DEPARTMENT OF TRANSPORTATION

National Highway Traffic Safety Administration

Federal Motor Vehicle Safety Standards; Occupant Crash Protection

ACTION: Final rule, correcting amendment.

Figure 6 - Sled Pulse and Coordinates

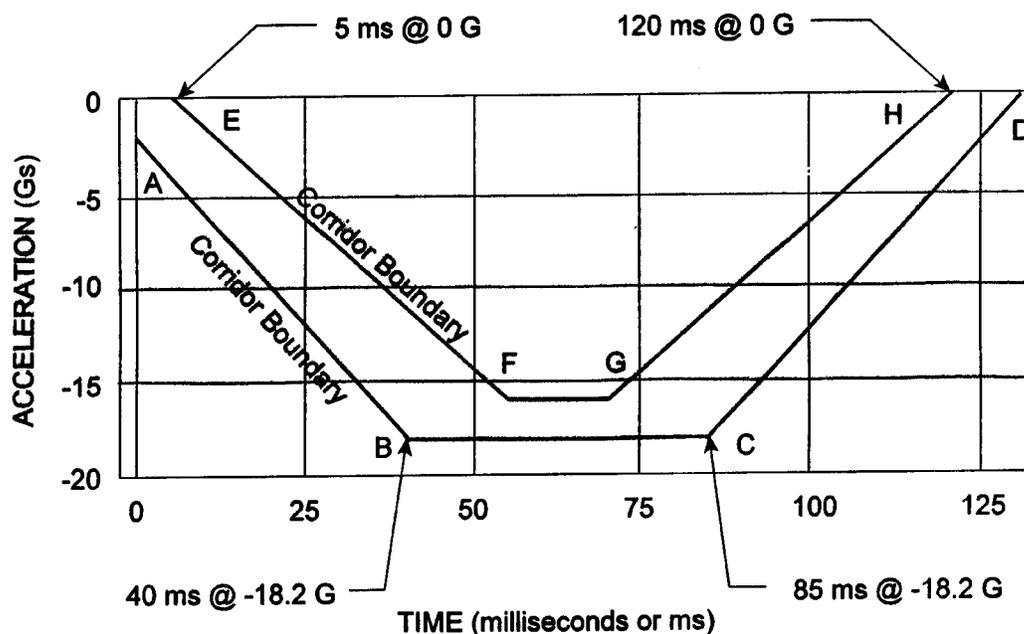
Honda and MIRA stated that the final rule was unclear regarding the definition of the Time-Zero (T-0, or start) for the actual sled test. They asked whether Time-Zero in Figure 6 of the final rule sled pulse represents (a) the instant when the sled system is activated, or (b) the instant when the sled reaches 0.5 g's. They believe there are problems in either case. If T-0 is the time when the sled is activated, some sleds will have extreme difficulty fitting

Figure 6 of the March 19 final rule indicates that the test begins when the sled actually starts to move, at 0.0 g acceleration, but that too is impractical. In its June 10 presentation, Honda provided initial sled pulse traces for both the VRTC 24-inch piston and a 12-inch piston. These traces indicated that the 24-inch cylinder sled took 18.1 milliseconds to achieve 0.5 g's, yet the corridor ends at the 0.5 g's level at 6.5625 ms. Therefore, even the faster acceleration of the 24-inch sled would be outside the corridor, if T-0_{Test} started at 0.0 g acceleration, when the sled starts to move. It appears that even after the sled begins moving (although it moves only the width of a pencil line), the time lag before it begins significant acceleration is so great that no existing sled can produce an acceleration curve that stays within the corridor. This time lag has no counterpart in rigid barrier vehicle crash tests because the deceleration is instantaneous when the vehicle hits the barrier. The figure in the final rule portrayed unrealistically rapid increases in acceleration from the start of movement.

To carry out this intent, it makes sense to shift the corridor with respect to time to align it with the true sled pulse, rather than having the sled pulse aligned with the corridor. As long as the shape of the corridor is not changed, the crash pulse will be no different from the standpoint of designing safe air bags. It will just be easier to run the test, without affecting the outcome. To accomplish the process of fitting the corridor to the sled pulse, $T-0_{\text{Test}}$ should be determined by a specific acceleration level for the sled which corresponds to a time at which the most rapid acceleration begins, at about 0.5 g's. Computationally shifting the corridor to align with the curve is far easier than trying to mechanically get the sled pulse curve to begin rapid acceleration within the corridor. Starting at 0.5 g will also eliminate much of the problem mentioned above in issue 1 concerning noise during the earliest part of the test acceleration.

Therefore, S13.1 and Figure 6 are being amended to reflect that the sled test start time for purposes of meeting the requirement of being in the corridor, $T-0_{\text{Test}}$, is when the sled achieves 0.5 g's. Many test laboratories use $T-0_{\text{Test}}$ equal to a specific acceleration (g) level, often 0.5 g's. The vehicle will still have to achieve the specified range of acceleration during the test. Similarly, the time at which the air bag fires is only relevant if it relates to when the sled starts accelerating at a significant rate, such as 0.5 g's. Therefore, the air bag deployment timing should also be timed from the time at which the sled reaches 0.5 g acceleration. $T-0_{\text{Test}}$ and $T-0_{\text{Air-bag}}$ coincide.

- 3. Figure 6 is revised to appear as follows:

Sled pulse for $\Delta V = 30(+0,-2)$ mph. The Time Zero for the test is defined by the point when the sled acceleration achieves -0.5 G's.
